**Erskine Park Waste and Resource Management Facility
Modification to approved SSD 7075
Environmental Assessment Report**

Cleanaway

May 2018

Figure 4 Reinstatement of access road at south-east corner

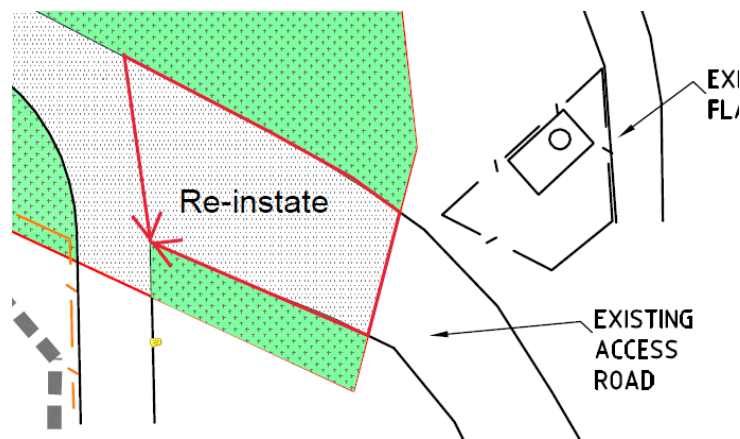
Modification 3 proposes to reinstate a section of the access road between the existing landfill access road and the new landfill exit ramp in the south-east corner as shown by the red boundary in Figure 4. This area was shown as landscaped area in Modification 1. The current proposed modification would reinstate the access using an unsealed road and would not therefore impact the area of hardstand or impervious surface area on the site.

PROPOSED SITE LAYOUT - STAGE 1 - MOD 3		DATE MARCH 2018	
DEVELOPMENT CONSENT		SCALE AS SHOWN @ A3	
DRWG. No.	DOCUMENTATION JH	SHEET. No.	REV.
17567	DRAWN JH	003	18
	CHECKED ND

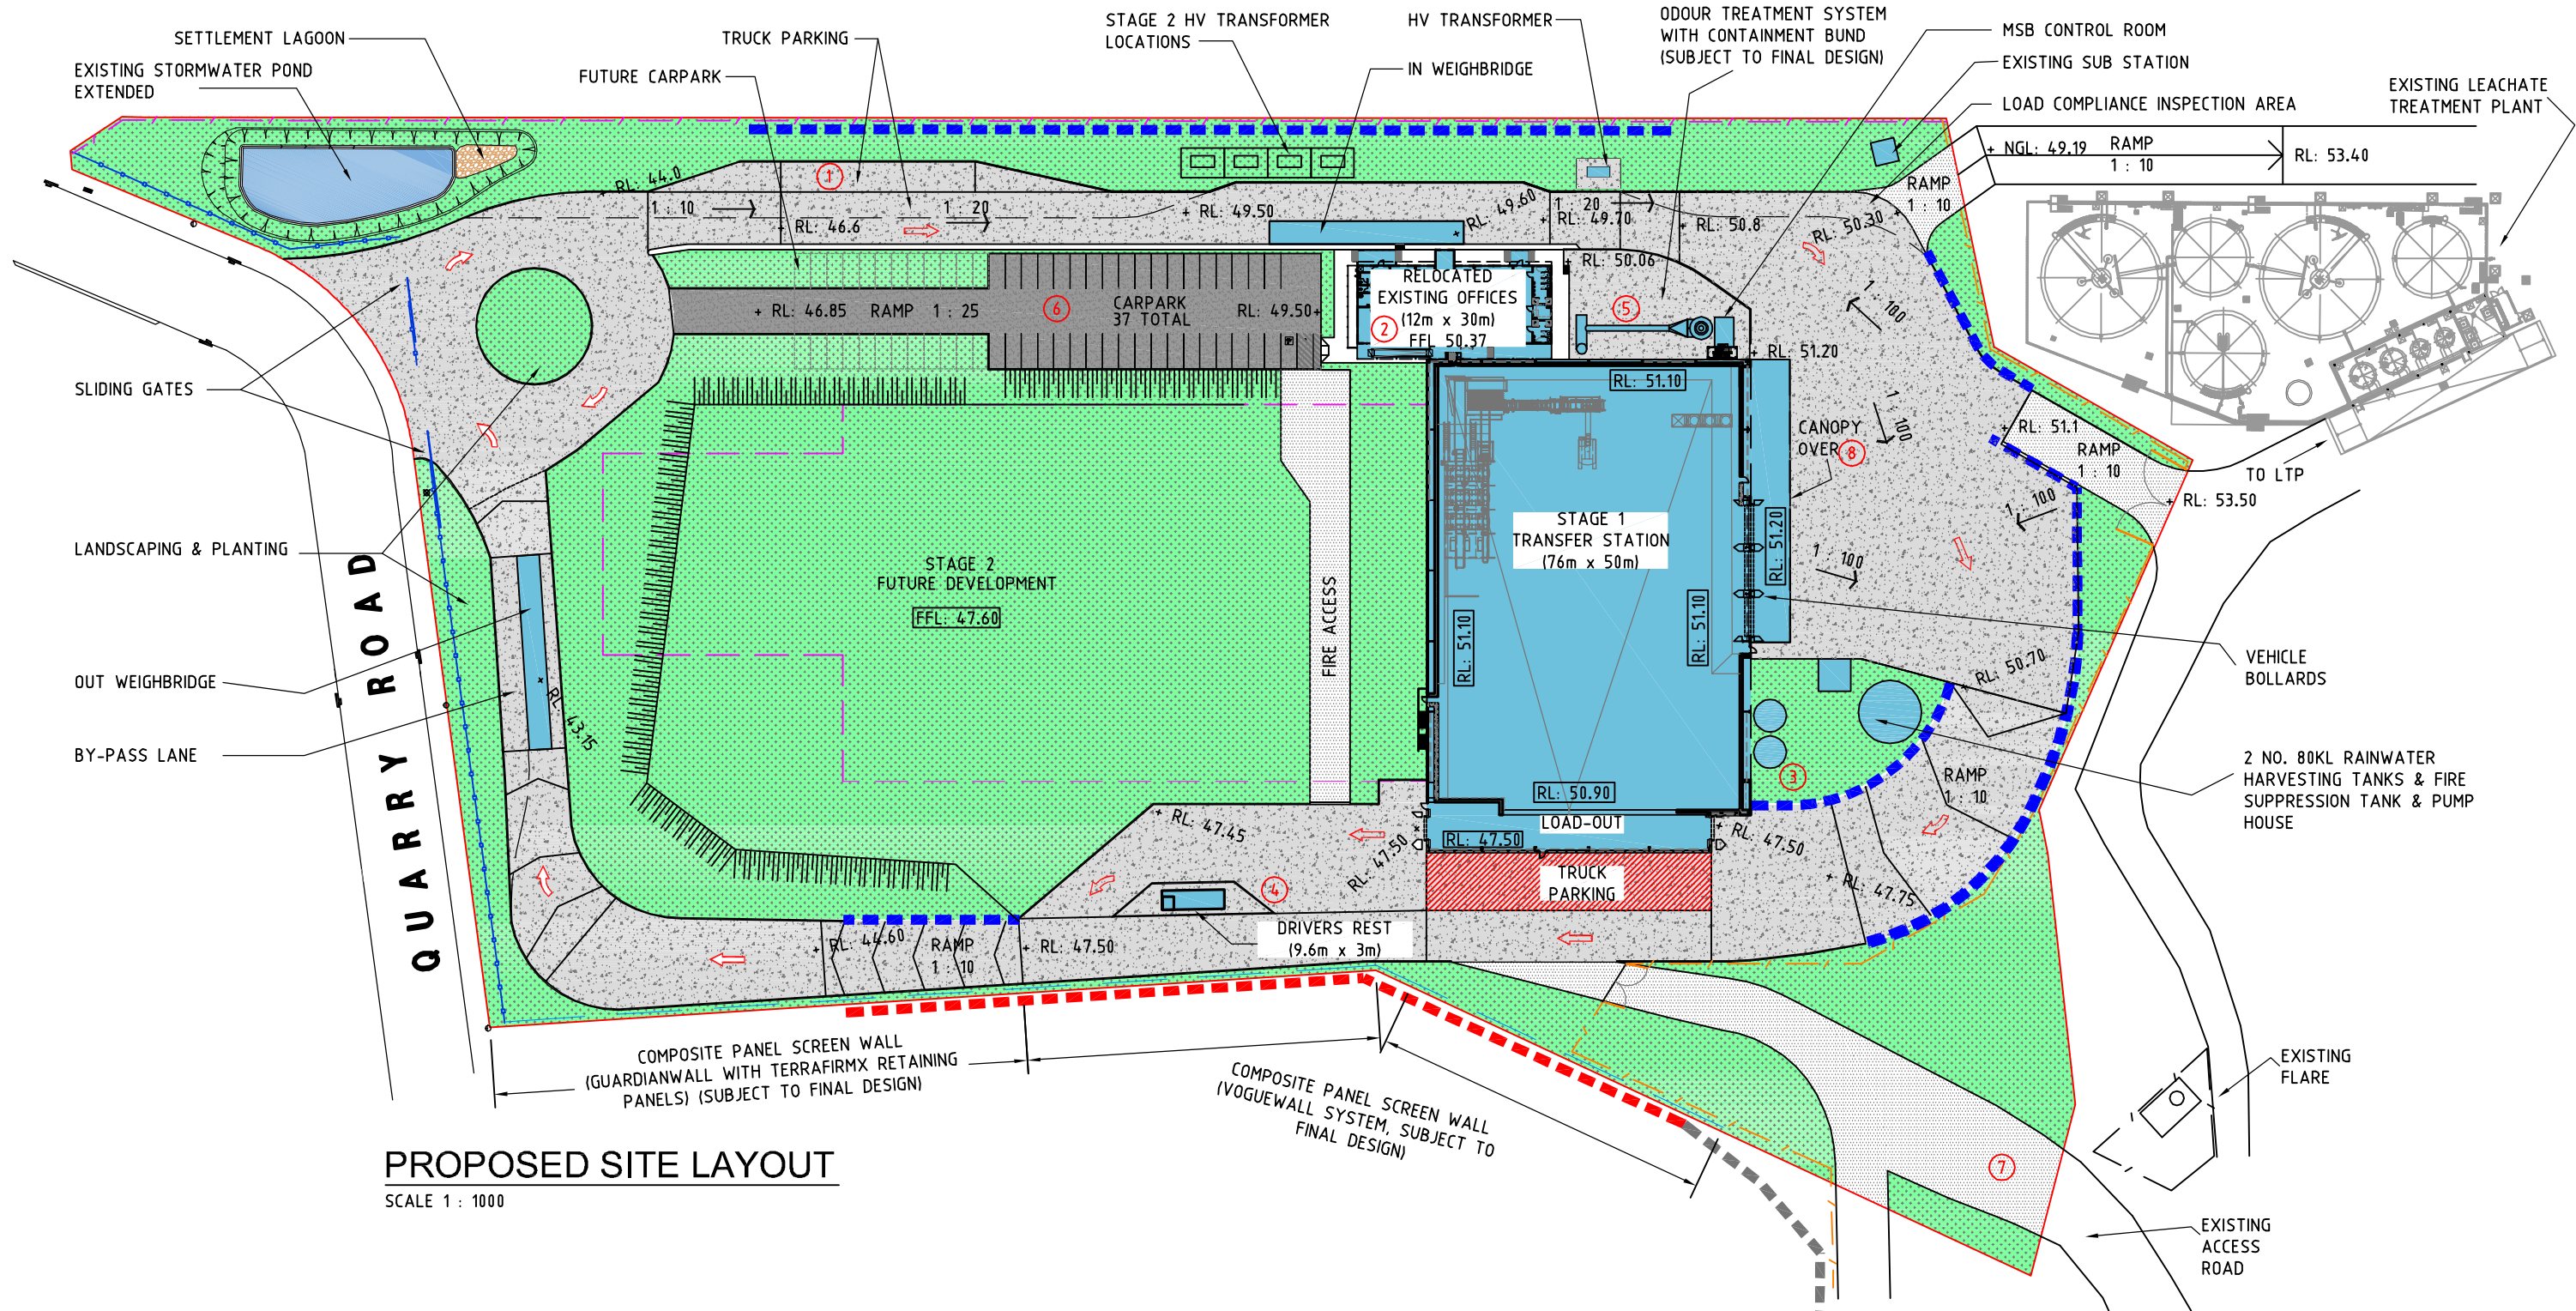
- SCHEDULE OF CHANGES
1. ADDITIONAL TRUCK PARKING TO NTH DRIVEWAY
 2. OFFICE LAYOUT REVISED
 3. PROPOSED STAGE 2 ADDITION DELETED, 2x80KL RW TANKS NOTED
 4. DRIVERS REST ADDED TO STH DRIVEWAY
 5. NTH ELEVATION DUCT WORK REVISED
 6. ADDITIONAL STAGE 1 CAR PARKING
 7. EXISTING ACCESS ROAD IN STH WEST RETAINED
 8. EAST CANOPY RAISED BY 500MM
